Peach Bottom Atomic Power Station, Units 2 and 3
Facility Operating License Nos. DPR-44 and DPR-56
NRC Docket Nos. 50-277 and 50-278

Subject: Response to Request for Additional Information Related to Severe Accident
Mitigation Alternatives

ATTACHMENT 1

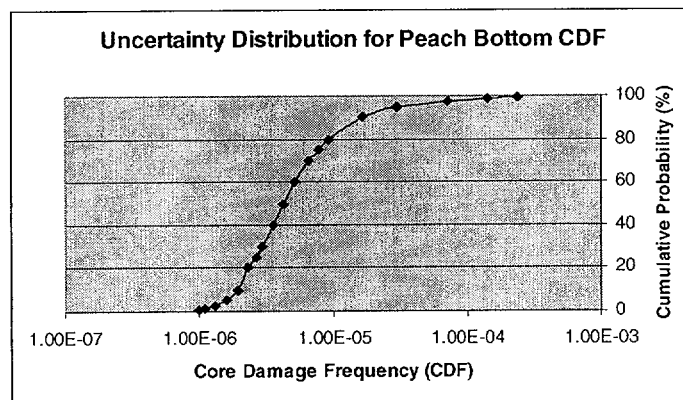
3. ***In assessing the costs associated with core damage events at Peach Bottom, neither the impact of uncertainties nor the contribution of external initiators (e.g., seismic, fires, etc.) have been considered. In this regard, please provide the following:***

A Monte-Carlo propagation of data uncertainty was performed for the Peach Bottom Unit 2 PSA model using the WinNUPRATM software. The results of that analysis are summarized below.

Confidence	CDF
5 th	1.57E-06
25 th	2.63E-06
50 th	4.24E-06
75 th	7.76E-06
95 th	3.00E-05

The 95th percentile associated with this distribution is 3.00E-05/yr. The SAMA baseline CDF of 4.5E-06/yr corresponds to approximately the 55th percentile of this CDF distribution. There are many factors to consider, however, when looking at the benefits of the SAMA candidates. Plant specific implementation of SAMA candidates may be complicated by space limitations, outage costs, regulatory requirements, and other considerations. These factors tend to result in underestimation of the costs. Additionally, the specific PSA analyses that were performed in addressing specific SAMA candidates were done optimistically. That is, the potential cost-benefit was derived from a case that maximized the CDF reduction that would result from implementation of the SAMA. Both of these factors would, in effect, offset the uncertainties associated with the CDF estimates.
